Technical Note 1	
Leeds Road, Kirklees	
Job number:	J0737
Document number:	J0737/2/D1
Date:	18 January 2024
Client:	c/o KPP Architects
Prepared by:	Mr Bob Thomas

1.1.1 This technical note provides a response to comments made by Kirklees Council on the Air Quality Assessment submitted in support of the outline planning application for a warehouse at Leeds Road, Mirfield, application number 2023/60/92448/E. Kirklees Council Environmental Health (Pollution & Noise Control) provided a response on 11<sup>th</sup> September 2023, responding reference WK/202327411. With specific reference to air quality, the following comments have been made by Kirklees Council:

**Figure 1: Measured Annual Mean NO<sub>2</sub> Concentrations at Diffusion Tube K6**

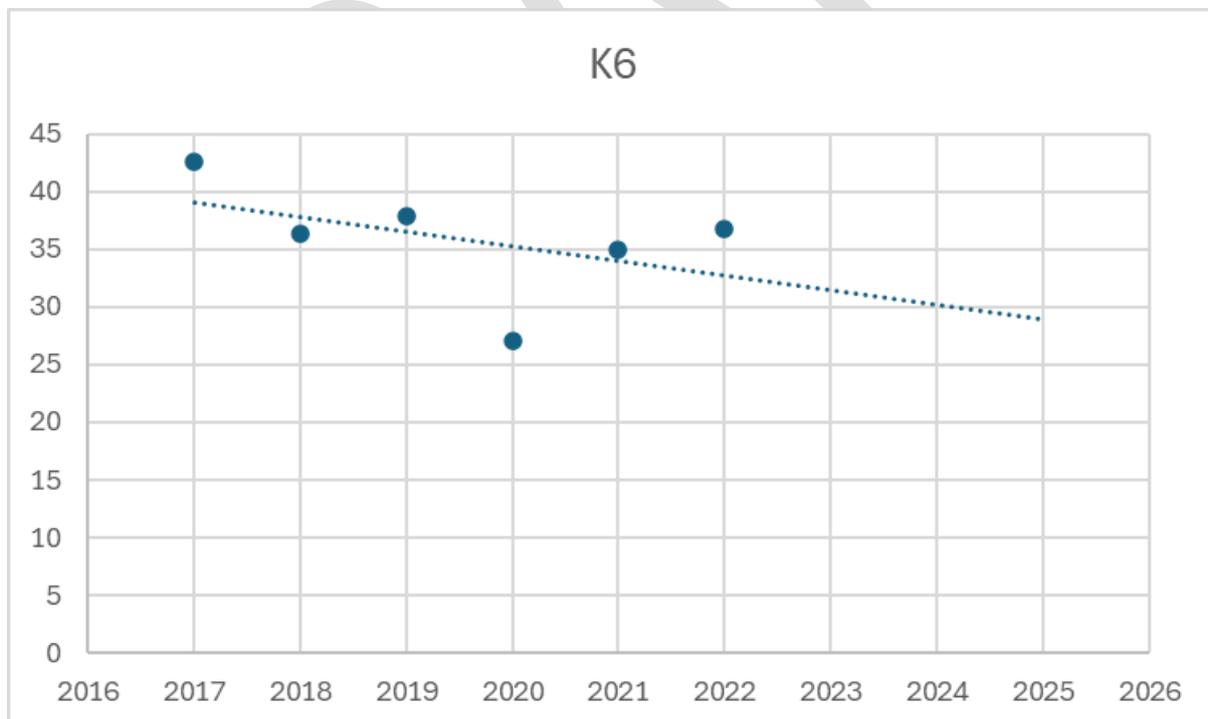
*K6 is the nearest roadside diffusion tube to Rose Cottage R1. According to our latest monitoring figures taken from the 2023 ASR which is yet to be approved by DEFRA, the 2022 annualised concentration for K6 at roadside is 36.8  $\mu\text{g}/\text{m}^3$  and at the nearest receptor façade is 31.2  $\mu\text{g}/\text{m}^3$ . However, the predicted modelled concentration for the 2025 Do Minimum (DM) and Do Something (DS) scenarios as depicted in the assessment is 20.0  $\mu\text{g}/\text{m}^3$  respectively. This would suggest a reduction of 11.2  $\mu\text{g}/\text{m}^3$  over 3 years, this requires further explanation given the nature of this extremely busy junction.*

- 2.3.4 Measured annual mean NO<sub>2</sub> concentrations at diffusion tube monitoring site K6 are represented in a graph in **Figure 1**. The graph also shows a trendline projected forward to 2025. There is a falling trend in annual mean NO<sub>2</sub> concentrations, with a projected annual mean concentration of around 29µg/m<sup>3</sup> at diffusion tube monitoring site K6 in 2025. The annual mean NO<sub>2</sub> concentration predicted at diffusion tube monitoring site K6 in 2025 without the proposed development is 21.4µg/m<sup>3</sup>. Therefore, assuming annual mean NO<sub>2</sub> concentrations continue to decrease at diffusion tube monitoring site K6 at the same rate as between 2017 and 2022, the model may underpredict concentrations at this location.

- 2.3.5 Receptor R1 is close to diffusion tube monitoring site K6, but at the façade of a dwelling approximately 9m further from the kerb of the A62 than the monitoring site. The predicted annual mean NO<sub>2</sub> concentration at receptor R1 is 1.4µg/m<sup>3</sup> lower than

at the monitoring site in 2025. Therefore, an estimate of the 2025 annual mean NO<sub>2</sub> concentration at receptor R1, based on the decreasing trend in annual mean concentrations at diffusion tube monitoring site K6, is around 28µg/m<sup>3</sup>, well below the annual mean objective of 40µg/m<sup>3</sup>.
